FOREST LAKES FILINGS 5, 6 & 7: PUD DEVELOPMENT/PRELIMINARY PLAN MAJOR AMENDMENT

LETTER OF INTENT

DECEMBER 2018, REVISED FEBRUARY 2019

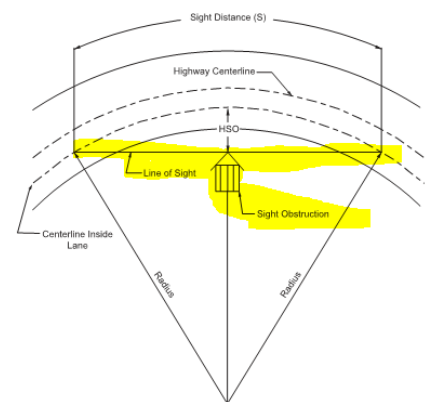
Since the minimum radius is significantly reduced, other design elements may be impacted. Therefore, additional analysis is required which may result in additional mitigation on the design. This is compounded by a 10% grade which also exceeds the standard criteria.

- a. The 200' radius is based on a 25mph design/posted speed. What is the safe design/posted speed to be used for the 100' radius? Provide the calculations
- b. Based on the safe operating speed, what is the new SSD. Show the line of sight. Provide the calculations.
- c. Provide an autoturn exhibit with a WB-50 design vehicle. Applicant needs to demonstrate sufficient lateral clearance between the edge of the traveled way and the vehicle body and wheel path. a wider width at the turn may be required.
